PLANNING COMMISSION AGENDA

Title: Final Site Plan - Canyon Point In Centerville, 347 N 400 E - ADMINISTRATIVE DECISION

**PLANNING STAFF REPORT
AGENDA ITEM: 1**

Title: PUBLIC HEARING - Planned Development Overlay Amendment - Parrish Creek Business Park 1160 N 950 W - Tom Stuart Construction - LEGISLATIVE DECISION

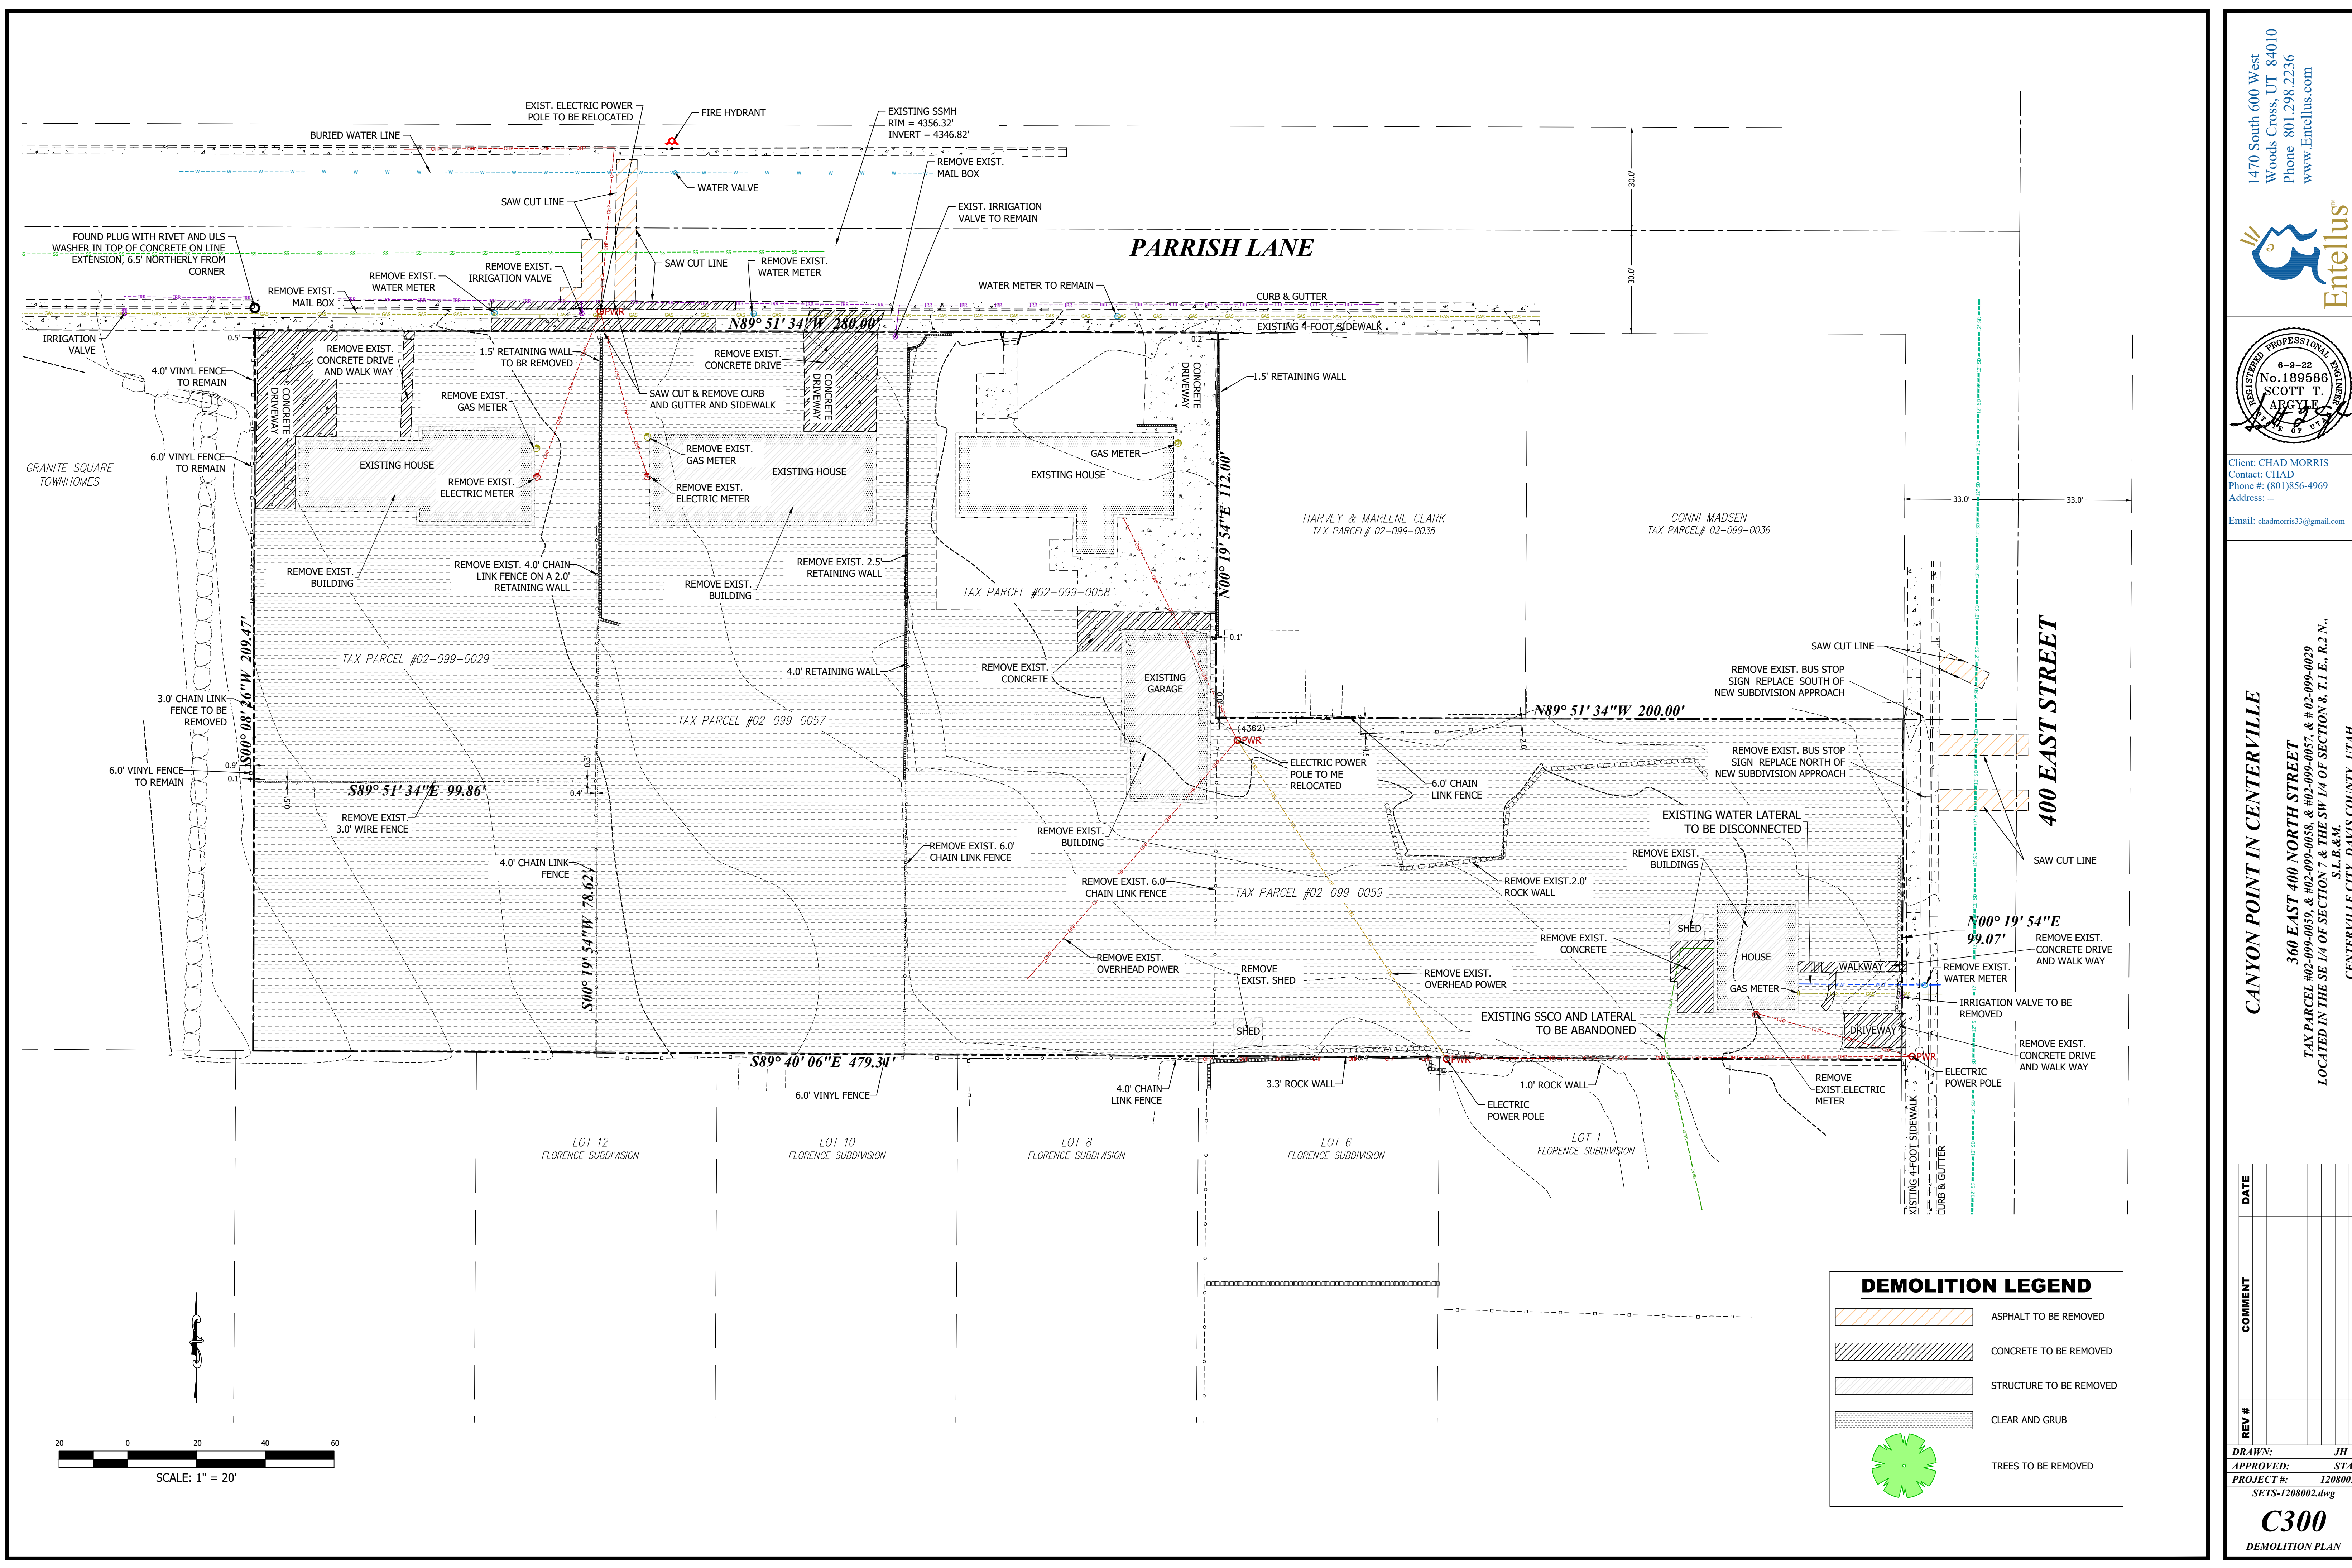
Staff Comments - The final site plan layout needs to ensure there is enough room for cars to exit the garages while cars are parked on the street. The likely distance from garage door to on-street parking or curb/gutter is 24 feet. It appears to have at least 29+ feet, when adding the depth of the driveways and the 20 feet of fire land clearance.

Staff Comments - The plans indicate trash will be managed privately by the HOA – see Note 1 on site plan. It appears to staff that since there are no dumpsters depicted, it will be done as an individual pick-up basis.

Staff Comments – The site plan depicts a combination of existing and proposed fencing that meets the requirements and limitations of the regulations. Additionally, the Final Plans depict the use of retaining walls at various locations throughout the project. Most of the retaining walls are less than 4-feet in height. However, one of the retaining walls will need to be engineered. This wall may be of concern if it exceeds a height of 4 feet in the Front Setback area along 400 North Street. It will need to be lowered to 4 feet or less when encroaching into the front yard setback.

[PROPOSED MOTION] *"I hereby make a motion for the Planning Commission to **APPROVE** the Final Site Plan for Canyon Point in Centerville Development, located at approximately 347 North 400 East, subject to the following conditions:*

1. *The Final Site Plan Approval consists of the following exhibit sheets:*
 - a. *Sheet C400 – Site Plan, dated 06-09-2022*
 - b. *L101- Landscaping Plan, Dated 5-24-2022*

- c. *Duplex Elevations A-2 and A-4, as submitted to the City*
 - d. *Single Family Elevations A2 and A-4, as submitted to the City.*
2. *The Final Site Plan shall be corrected and submitted, as follows:*

- a. *Front Yard Setback from 400 North shall be 25 feet unless it is modified by compliance with the Deuel Creek Design Incentive program.*
 - b. *All retaining walls located in the Front Yard Setback areas shall not exceed four (4) feet in height.*

PROJECT NO.	Arch D
SHEET NO.	L101

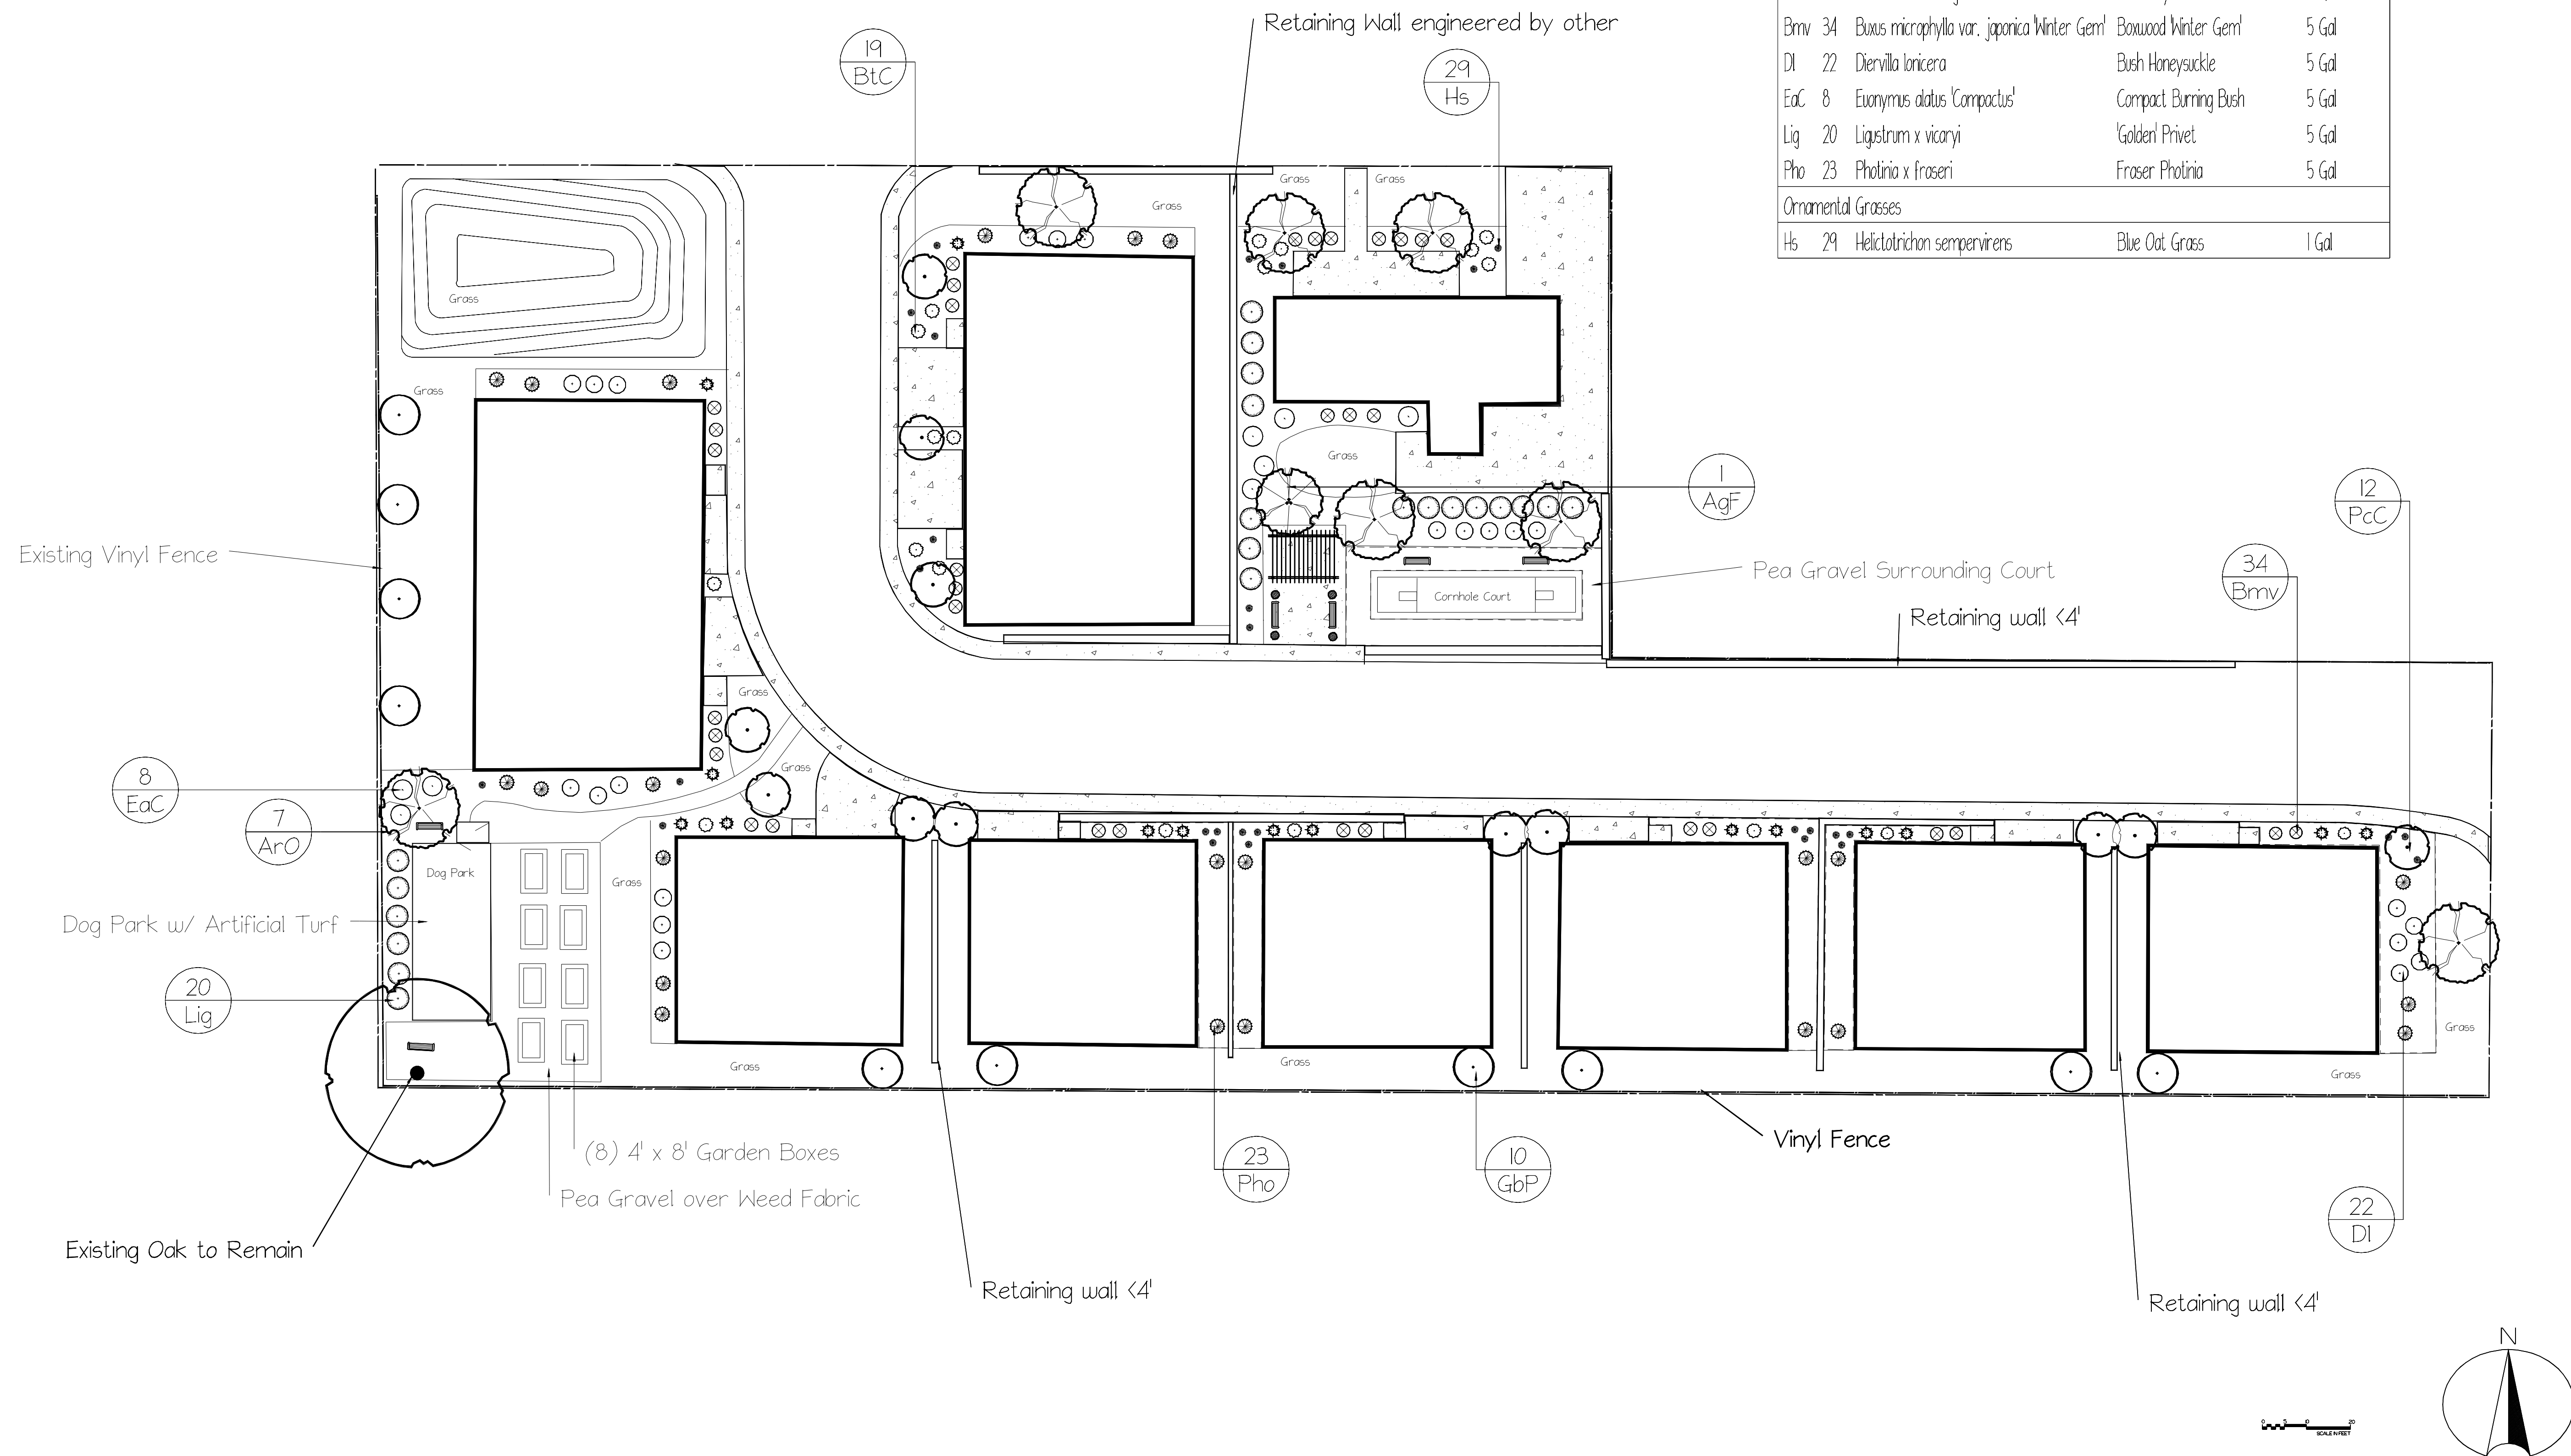
4. A final site plan shall be submitted as outlined in Section 12.21.110(e) of the City’s Zoning Ordinance. *[Completed 06/13/2022]*
5. The Final Site Plan shall provide a complete landscaping plan, designed by a Landscape Architect. According to 12.51.060 one tree and two shrubs shall be provided per dwelling unit. *[Completed 06/13/2022]*
